Re: State Significant Development Application SSD-65490715 – Bradfield Central Park

Attachment A – Detailed comments

Figure 3 Bradfield Central Park Design Proposal with Rail Protection Corridor

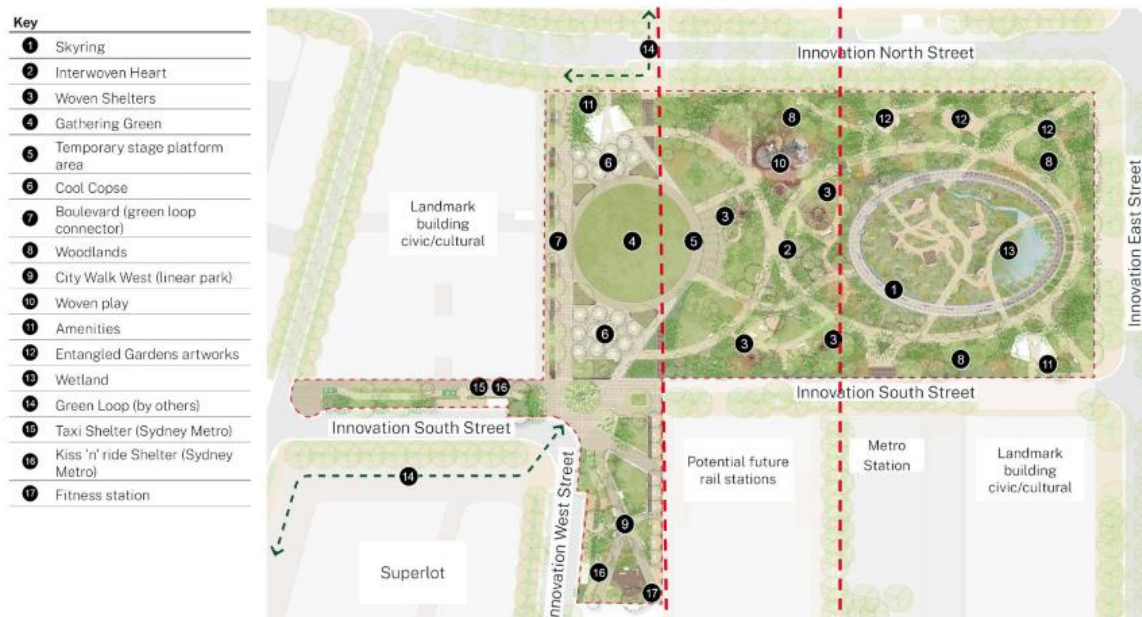
It is also unclear how the footpaths within the park in the area bounded by the rail protection corridor will be impacted, especially if the future rail is not underground. Figure 3, from the “Central Park, Bradfield City Centre – Rail Corridor Plan of Management,” below, indicates that the park will be significantly impacted if this link is not underground, see:

- ***A pedestrian desire line analysis is undertaken in relation to the identified pedestrian network in the exhibited Bradfield City Centre Masterplan. The desire line analysis should also consider potential adaptation of the park design in response to potential impacts of the Rail Protection Corridor that runs through Central Park.***
- ***Footpaths within the park should be aligned to desire lines identified within the desire line analysis or, alternatively that park design and planting is undertaken to prevent pathway erosion in areas where desire lines exist and where no path is provided.***

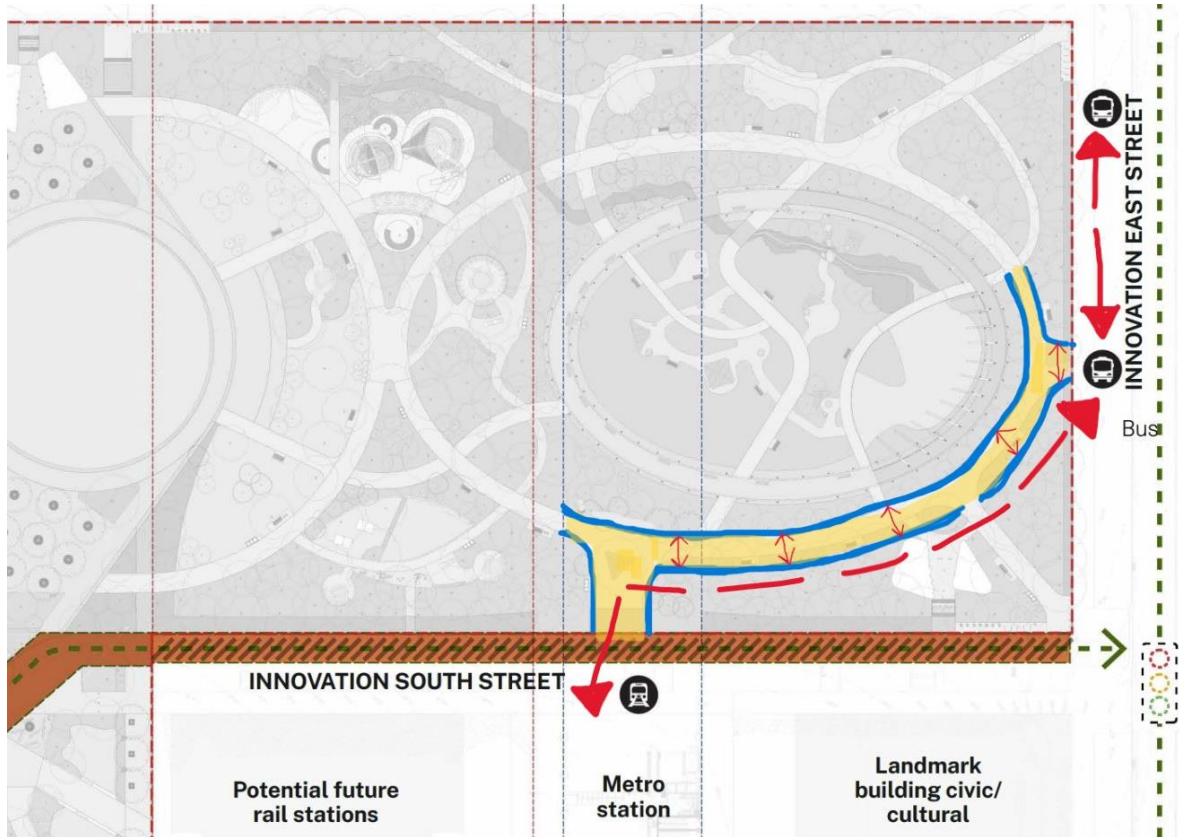
As previously raised by Council, the curved path (within Central Park) linking the Metro station and the bus interchange will likely be preferred by pedestrians, as the most direct route between the two key sites. In this regard, the capability of the proposed 3m wide path to accommodate a high volume of pedestrian traffic (particularly during peak hour), is questioned.

- ***As part of a revised proposal, it is strongly recommended that a wider path (including entry points) be considered by the applicant, to better accommodate a larger volume of pedestrian movement between the Metro and Bus Stations. (Refer to markup below);***
